HOSHIZAKI AMERICA, INC.

SERVICE BULLETIN

SB93-0009R

SUBJECT: CHANGE IN WATER SUPPLY SYSTEM

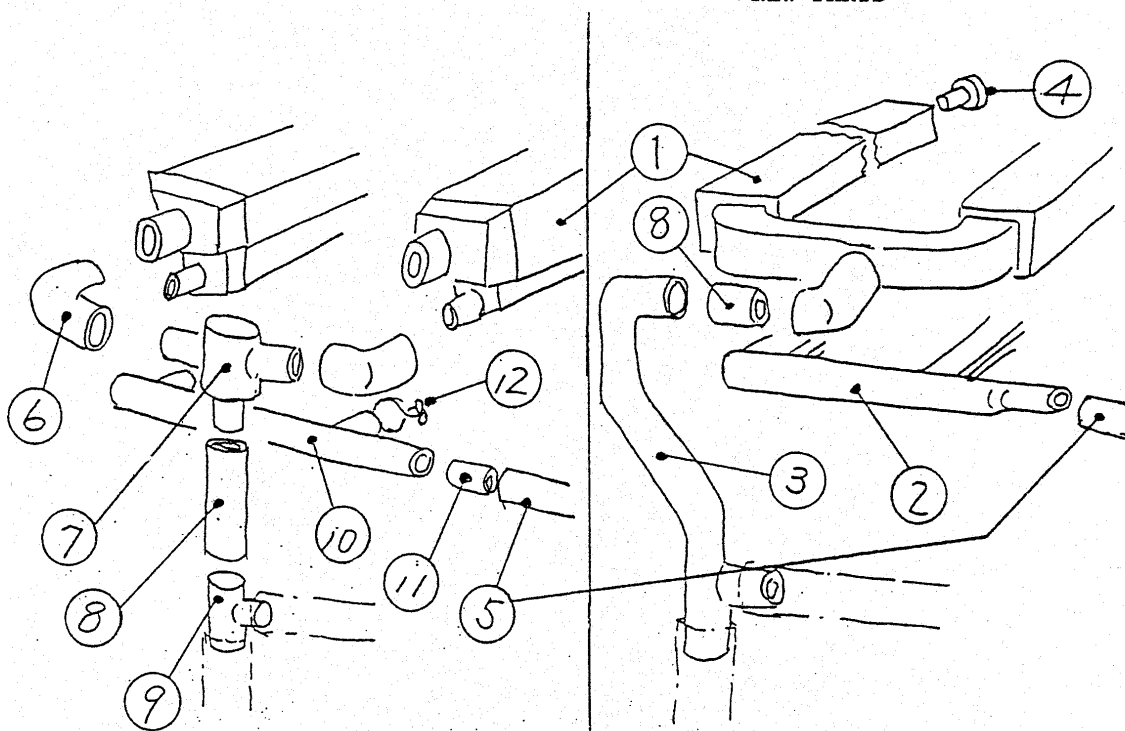
A recent design change was made in the water distribution system to incorporate a cleaning plug and a material change. This results in a reduction in the number of parts for the total distribution system and simpler removal and reassembly for cleaning. The change is effective on the KM-450/630/800 models.

The new parts are interchangeable as a set only. The old parts will remain available for service parts replacements, however, the clear material for the water spray tube will be changed to a cream colored ABS.
